CBD & South Eastern Light Rail Project

Royal Randwick Racecourse Response to Environmental Impact Statement

Submitted to Department of Planning and Infrastructure

Figure 2 – Equine Movement Zone Diagram

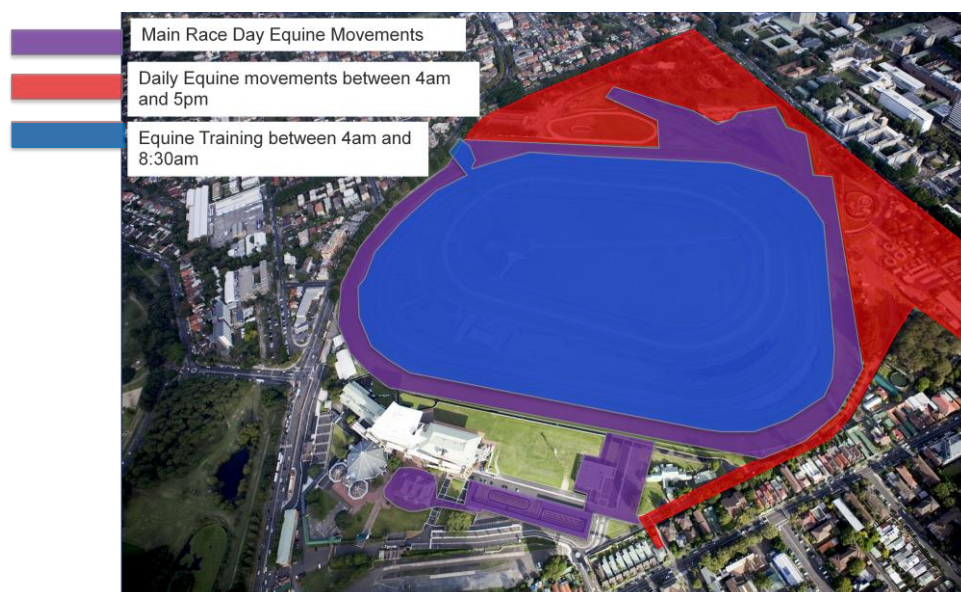
- In consultation with the ATC, prepare a Race Horse Management Plan which sets out the construction and management procedures both during and after construction of TfNSW and it's a third party contractor when dealing with horses. The Management Plan should include clear guidelines of construction and associated exclusion zones and project personnel education and induction processes to mitigate the risk of an event occurring that could result in damage or injury to a horse at RRR. The Management Plan must acknowledge and address the equine considerations which are included in this response.

Figure 4 & 5 – Spectator Precinct Location and Plan

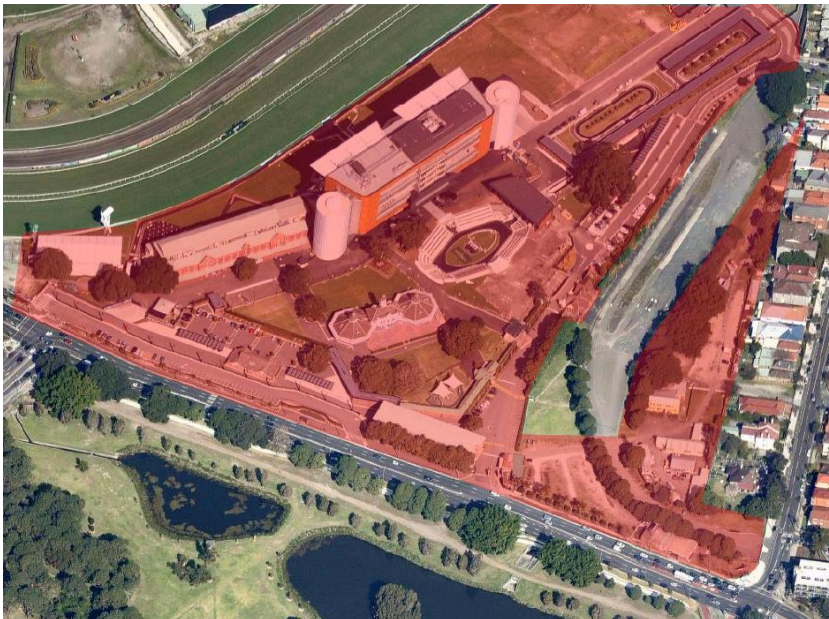
Due to the intersection not being traffic light controlled Gate 1 is currently closed during major events and access is via Doncaster Avenue. During major events the Ascot Street entry is used for equine vehicles, higher layover and taxis entering and exiting the taxi way. The Ascot Street gate is also used for ATC parking on Anson Land on major racedays including valet parking services. During minor events the majority of patrons enter and exit via Gate 1.

The EIS indicates that access via Gate 1 will be compromised during construction. It is not acceptable for access via Gate 1 to be significantly compromised during construction, especially in such a way as to impact on the capability of RRR to host its scheduled events. The Proponent will need to provide alternative access acceptable to the ATC and/or schedule construction works to ensure that the functional capacity of RRR is not diminished in relation to pedestrian access, all types of vehicle access both to the Spectator Precinct and the infield.

- The proponent should provide a detailed traffic management and construction staging plan to identify the impact during construction of proposed traffic and pedestrian management strategies to ensure the existing volumes of traffic, pedestrians and equine movements are catered for throughout construction safely.

- This intersection will need to be signalised
- The Gate 1 intersection must retain its existing right turn in and out capability;
- Shift access to the LRV Stabling facility to the Doncaster Road end of the site to lessen the conflict of uses at Gate 1;
- The ATC has recommended to the proponent that the ATC's design for the Cowper Street intersection be constructed to provide alternative access to the infield for heavy and light vehicles during events and the bump in and out thereof;

Figure 7 –Administration building

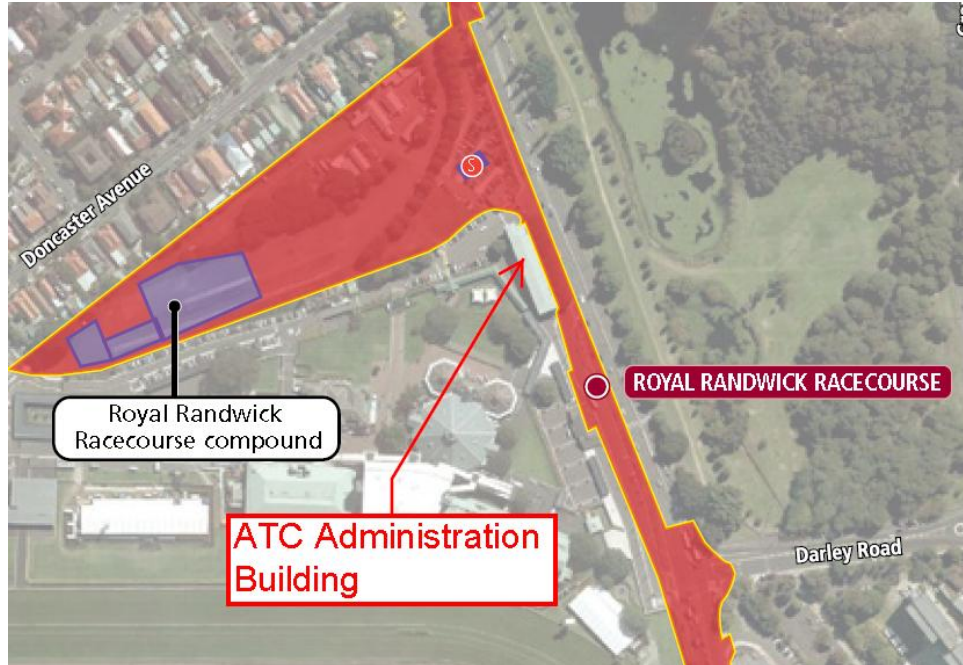
The light rail tracks pass only a few metres to the north of the Administration Building, and LRV would travel within approximately one (1 metre) of the building. Potential implications on the function and operation of this building include:

- the structural integrity of the building;
- existing services to building;
- awnings and external structures;
- vibration associated with ground works, construction and operation.
- internal acoustic environment;
- Loss of shade due to tree removal;
- Air conditioning system overload as a result of increased loads
- The EIS does not justify the close proximity of the electrical power cables to the Administration Building. In particular, the close proximity of the light rail power lines to the Administration Building has possible health effects and potential impacts on the performance of Visual Display Units and other electronic equipment.

Figure 8 – EIS image of Randwick Stop

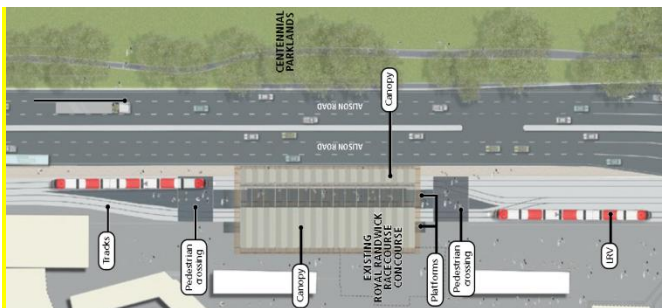
- The ATC invested millions of dollars in 2009 to reduce the patron safety risks through separating its patrons from Alison road. This was done through the installation of a busway to ensure that loading and unloading of buses could be carried out in a non-traffic environment away from the Alison Road carriageway. The TfNSW plan to relocate the buses to Lane 1 of Alison Road will be a backward step in terms of the pre-busway arrangement, with the added complication of a busy and active light rail line between the main entry/exit point for RRR and the buses.

- Investigations to establish the parameters of the station/stop and finalise the design detail and associated supporting documentation as to how the RRR Stop integrates with other modes of transport particularly in relation to special event operations;

- TfNSW must provide a detailed construction management and staging plan to explain how major event pedestrian and vehicle activity will be safely and efficiently managed around the RRR Stop construction zone and the balance of the Alison Road frontage.

Figure 11- Aerial Image of location for the new stabling complex and indicative light rail impact

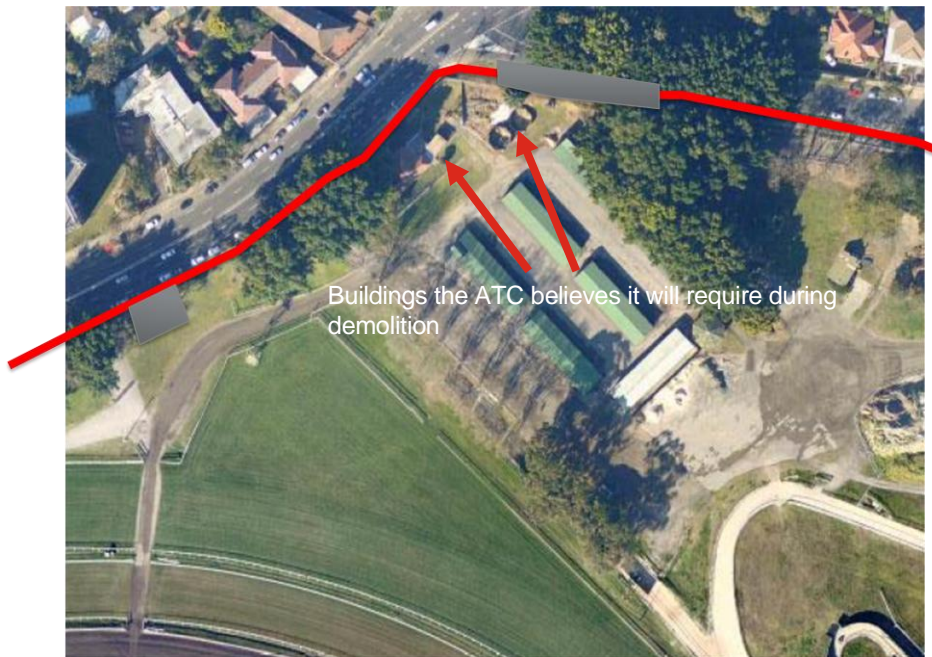
The scope of the approved stables redevelopment includes:

- The proponent must provide the Department with report identifying any impacts of the light rail on the approved stabling facility including recommendations on appropriate mitigation measures for the Department and ATC approval;
- Any amendments to the approved design and associated approvals must be managed and completed by the proponent at its cost prior to construction commencement of the light rail to ensure the revised design is able to be constructed.
- The estimated construction cost of the revised design must not exceed the cost of the original approval. If the cost does exceed the original approval cost the additional cost the proponent must compensate the ATC for this cost;
- The proponent must ensure that the ATC has the existing capacity to access the stabling site for construction during construction of the light rail project.

3.7.4 LRV Stabling Facility Access (Ascot Street)

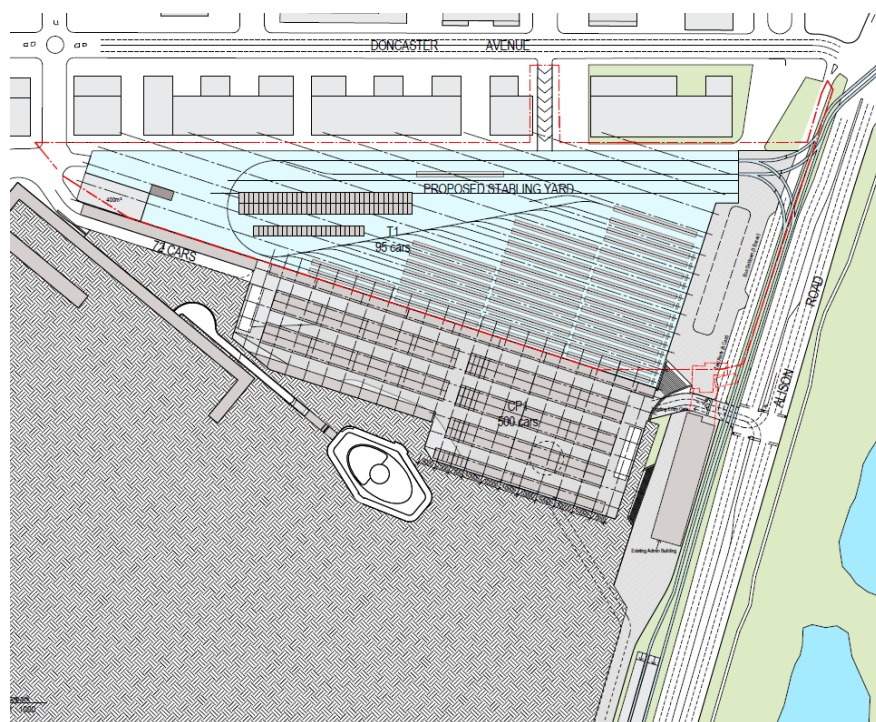
The EIS states that access to the LRV Randwick Stabling Facility would be via Ascot St (entry only) and Doncaster Ave (south of Allison Rd) – exit only. This is inconsistent with text in 5-83 and Figure 5.50 (page 5-70) which states that both access points would be entrance/exit. ATC supports the arrangement of a 1-way system with entrance off Ascot Rd and exit via Doncaster Ave. If either of these access points is modified to be entry and exit then the implications for the intersections should be further assessed.

The EIS states that the Randwick Stabling Site Office (to be used during construction) will be operated independently of the racecourse. Traffic management or Boom gates are likely to be required by TfNSW to control this access in particularly on event days. As stated in 6-47 the construction contractor(s) would be responsible for incorporating known special events into the construction program and detailed responses and contingencies in the construction traffic management plan.
